# MANATEE COUNTY FLORIDA

SUBJECT: **Invitation for Bid # 09-2568-OV**  
Buffalo Road Re-Alignment (North of Erie Road) and Waterline Relocation  
Project, Palmetto, FL  
**(Project No. 307.6062260)**

## ADDENDUM # 1

**Attachment 3**  
**Engineer's Response to Questions**  
**and Answers**  
**Road Realignment**  
**(8) Total Pages**

BUFFALO ROAD REALIGNMENT  
CROSS SECTIONS

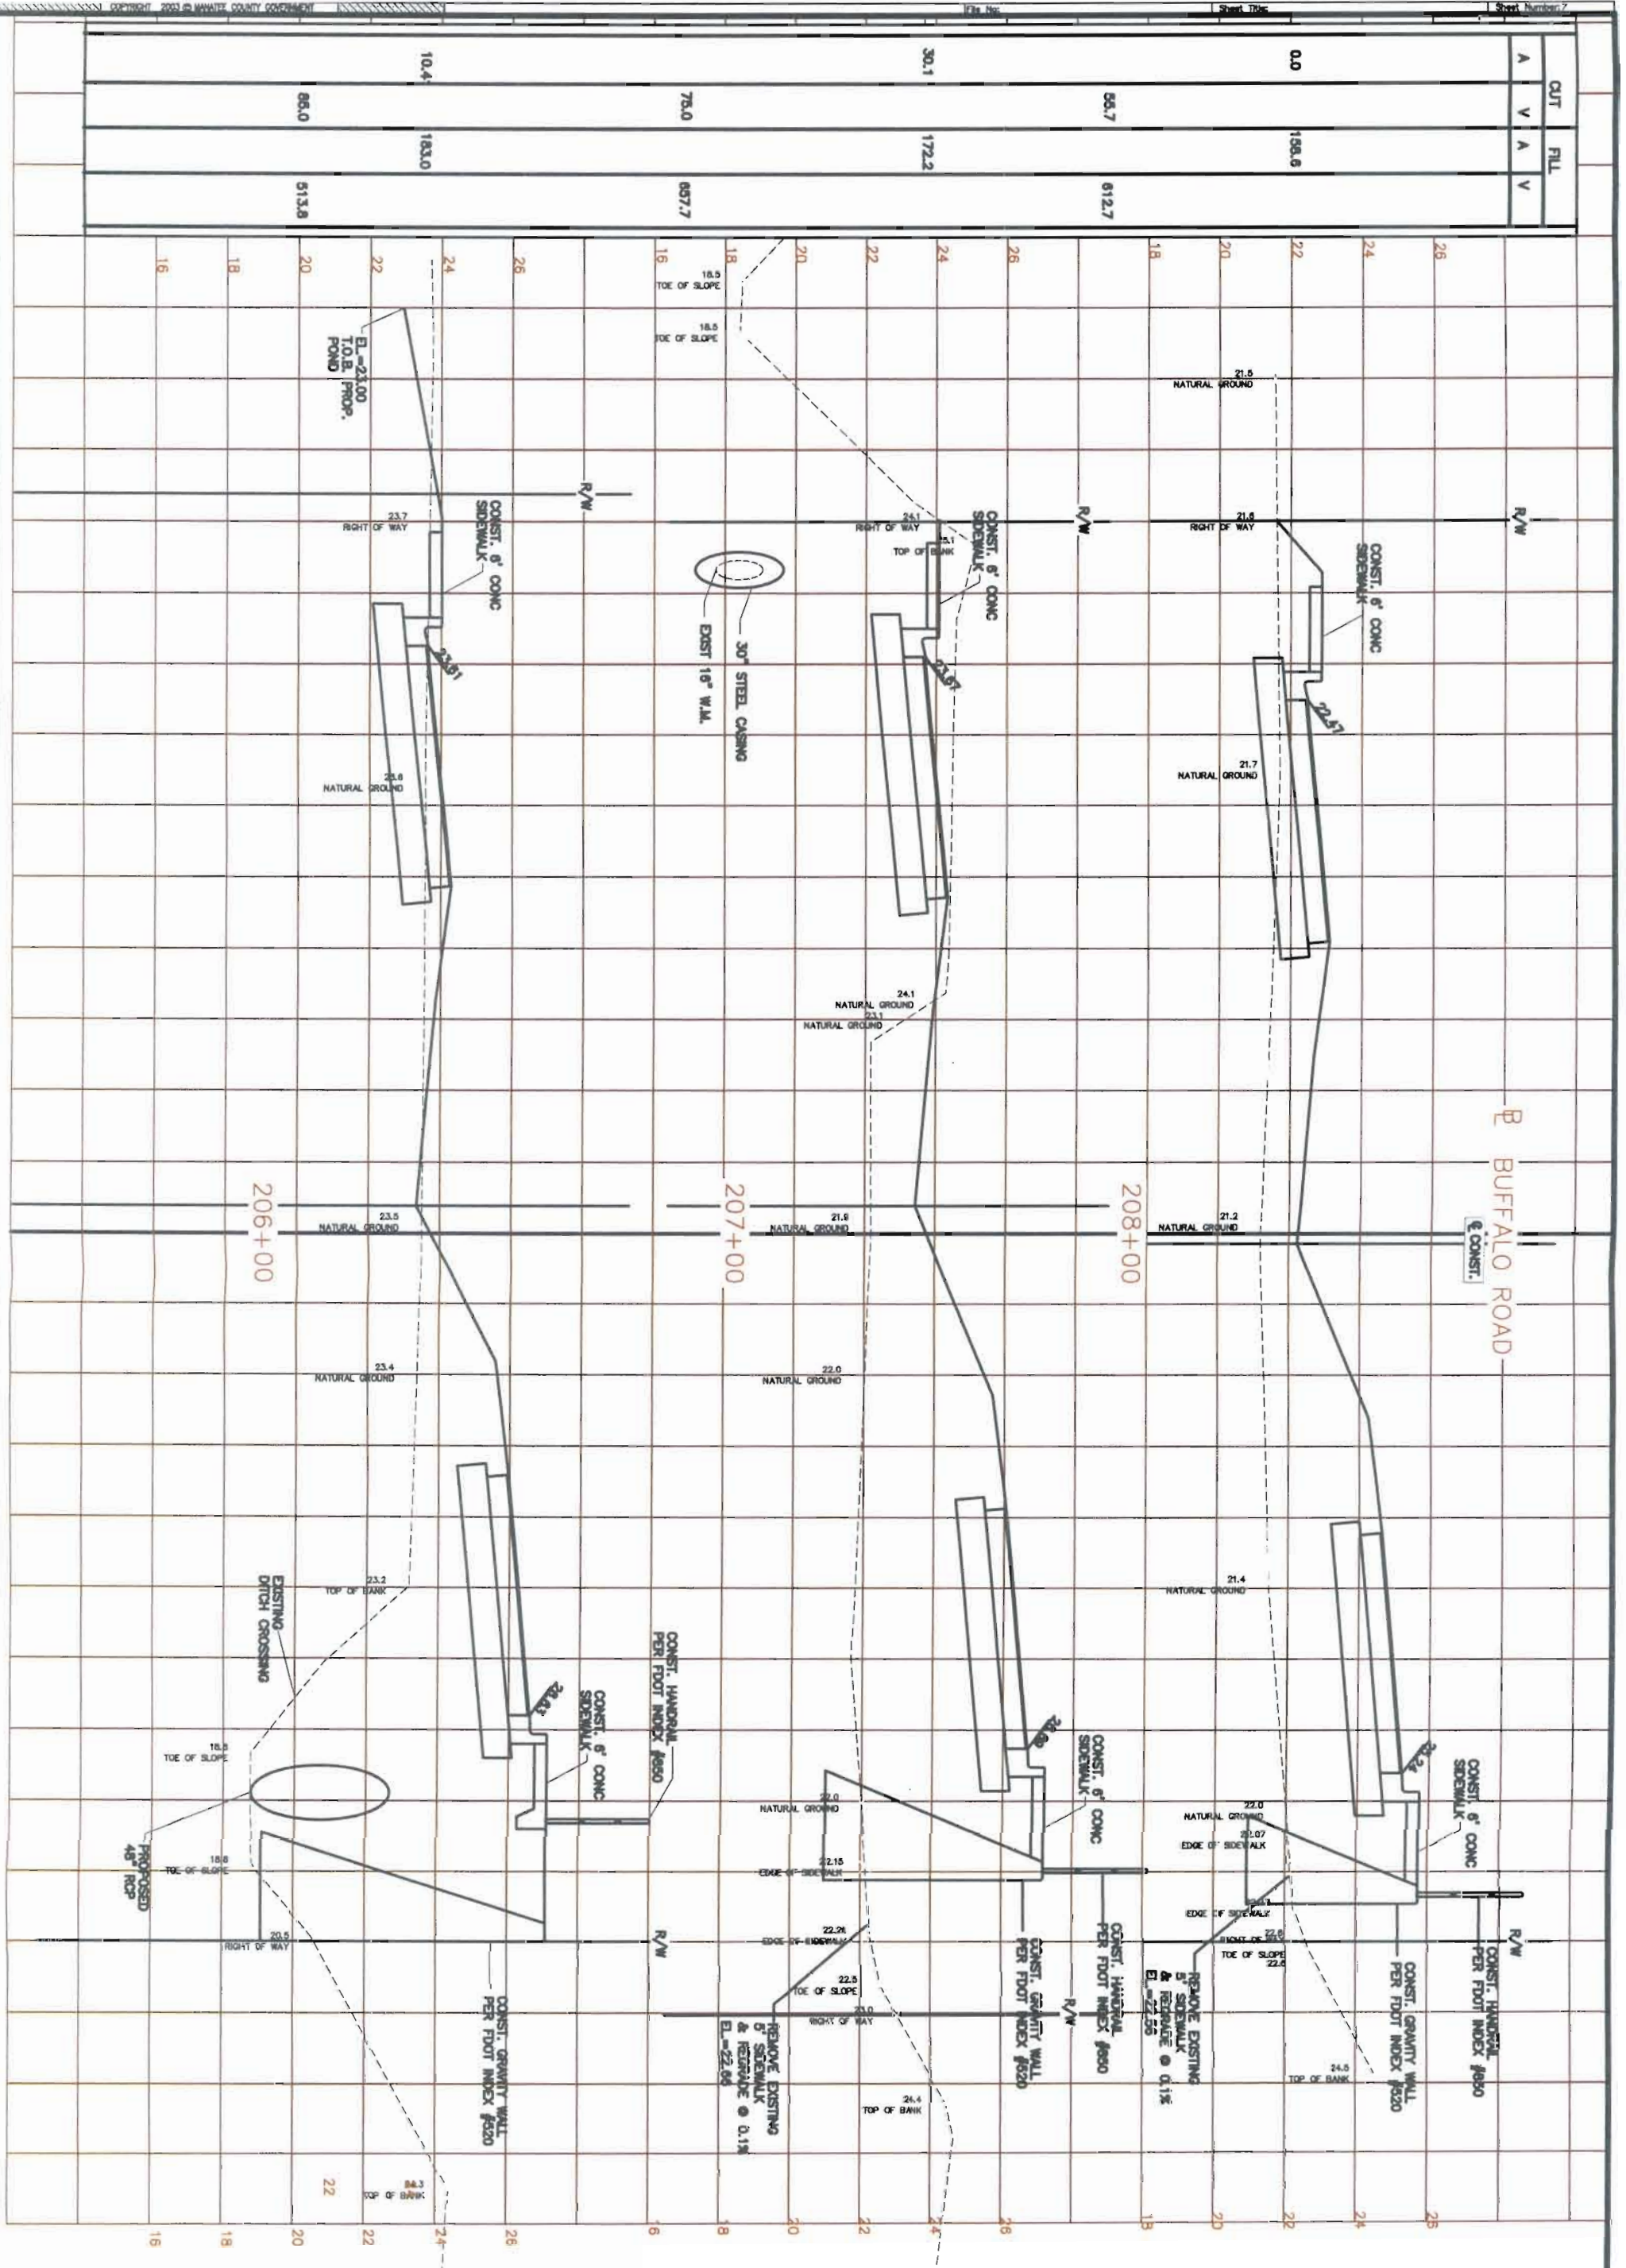
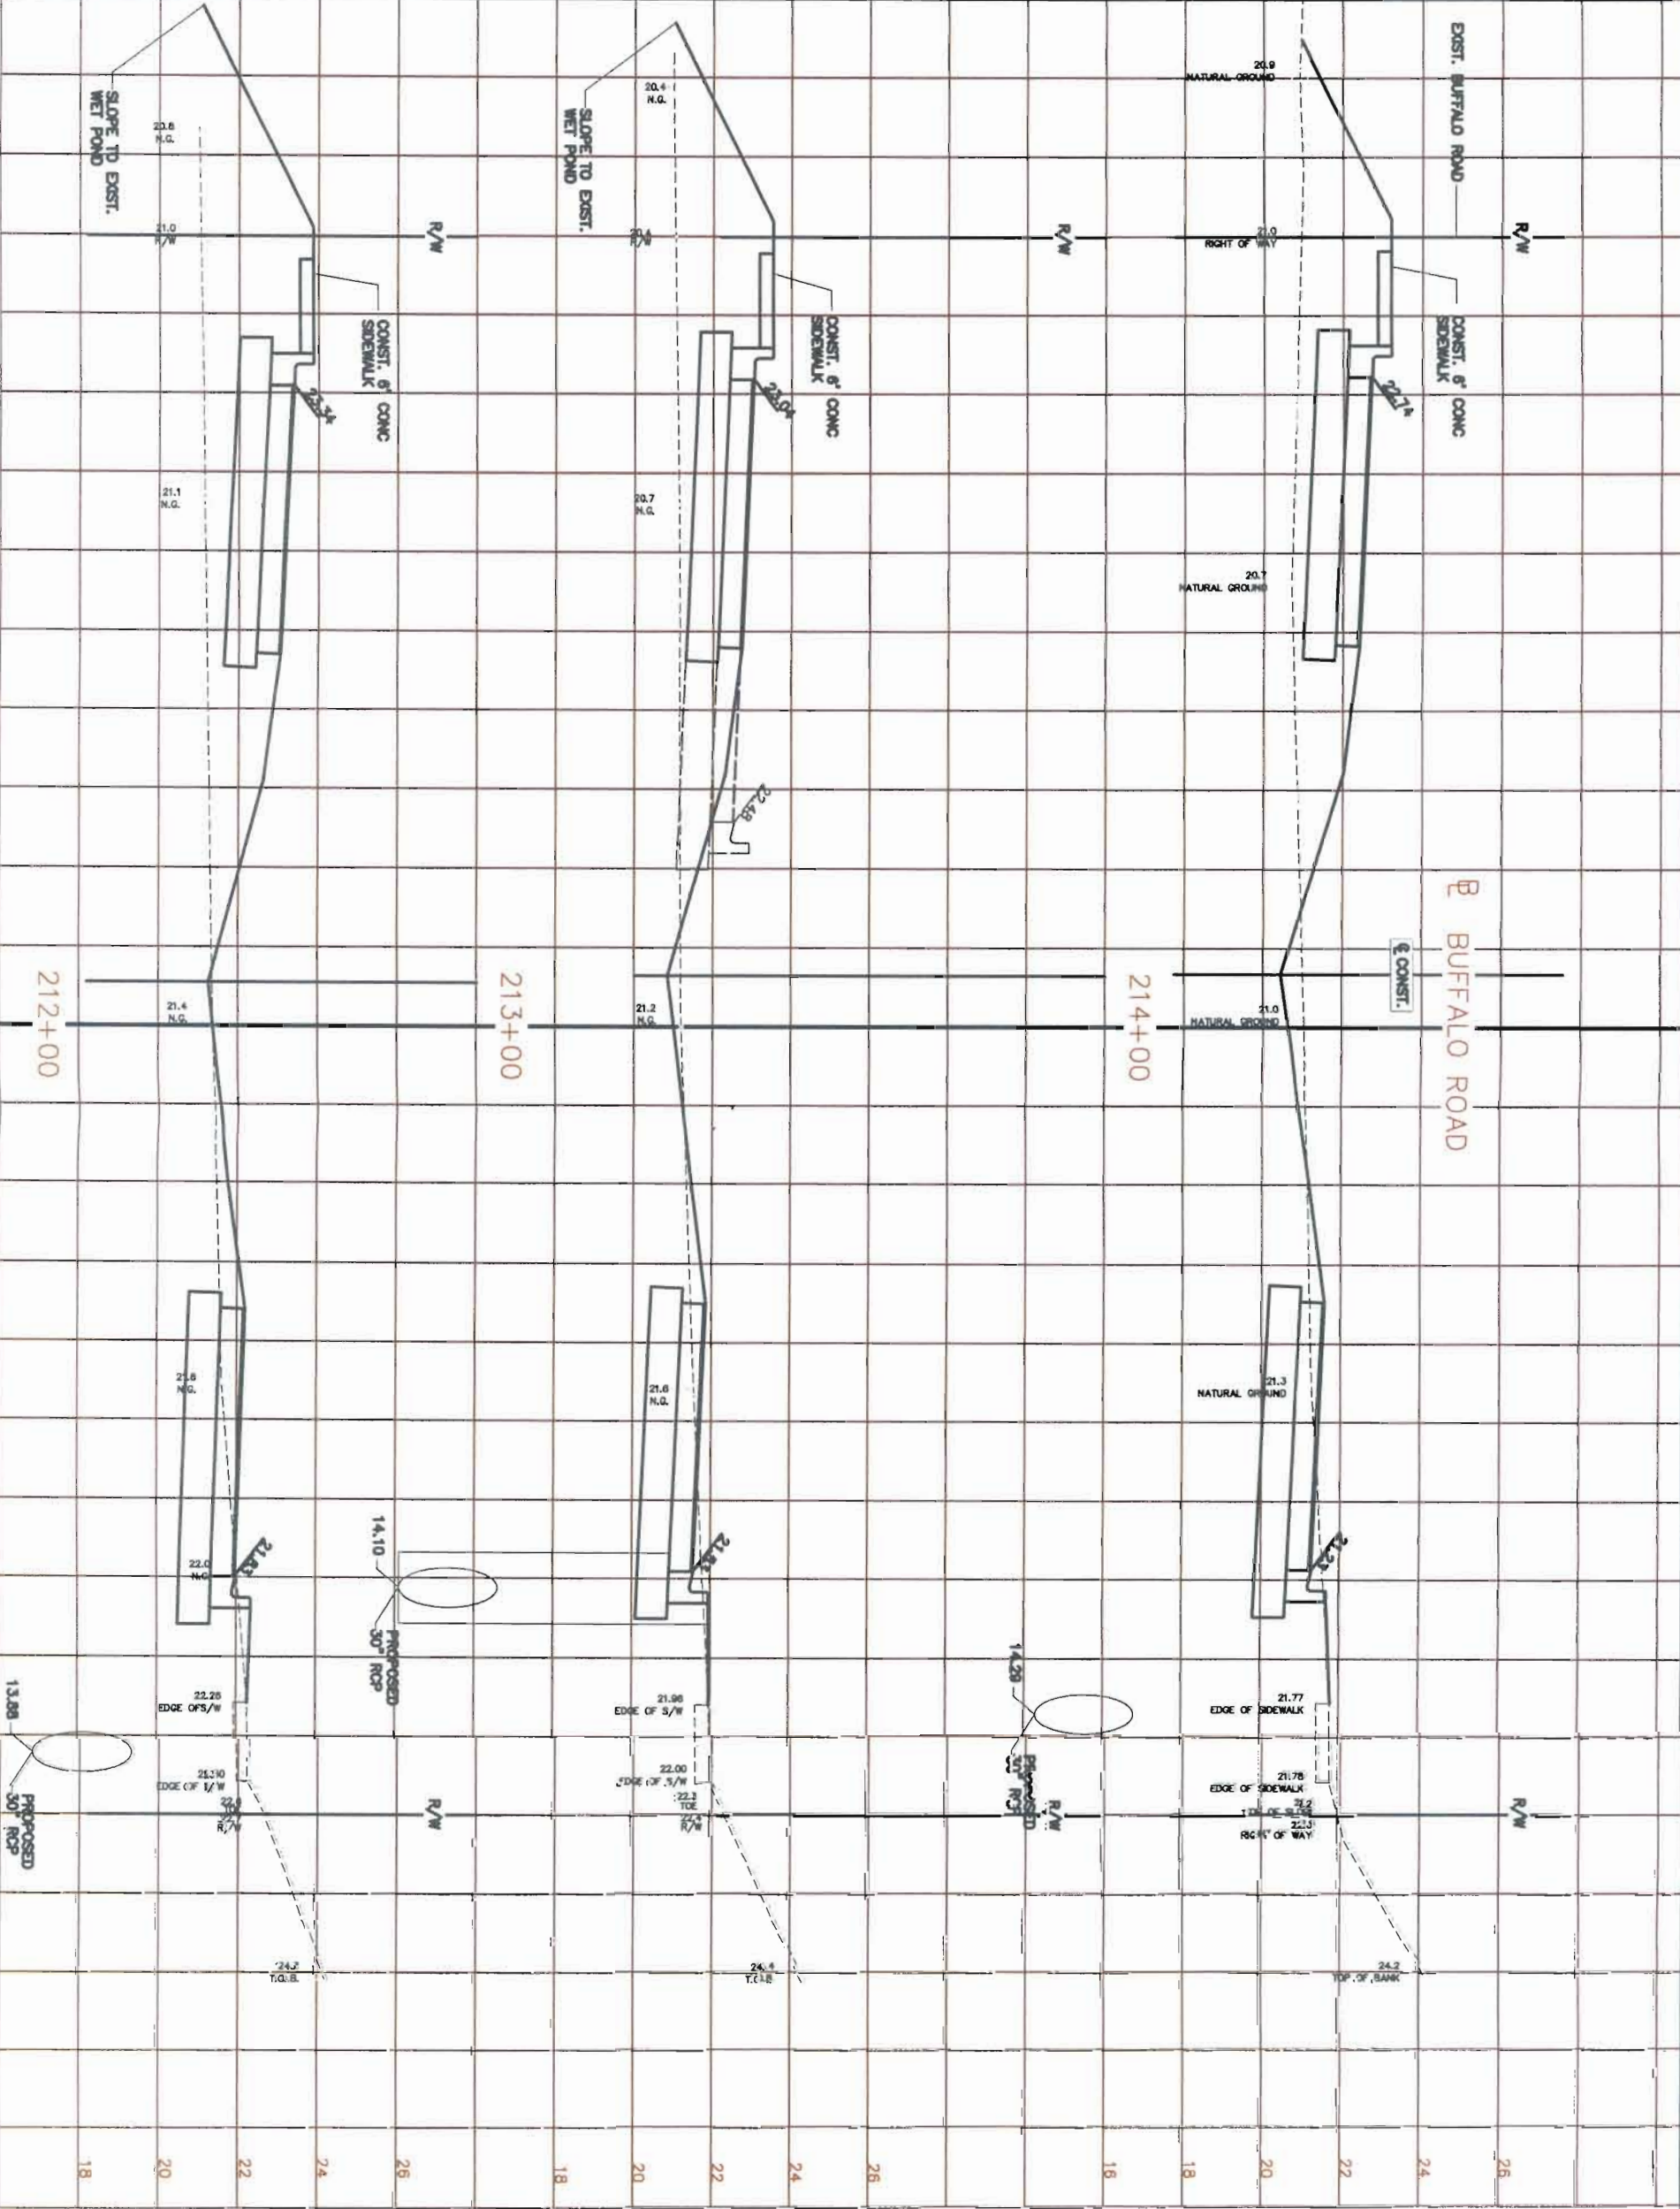
Q-4: The earthwork quantities appear to be incorrectly calculated.

Ans: The earthwork quantities have been reviewed using the end area method; Bid Forms have been updated to reflect this change. The earthwork has been divided into the following items:

Bid Items	FDOT Items		
7	0120- 1	Regular Excavation	8,433 cy
8	0120- 2	Borrow Material needed	2,424 cy
9	0120- 4	Obliteration (Old Buffalo Road)	6,150 cy
10	0120- 6	Embankment	10,857 cy
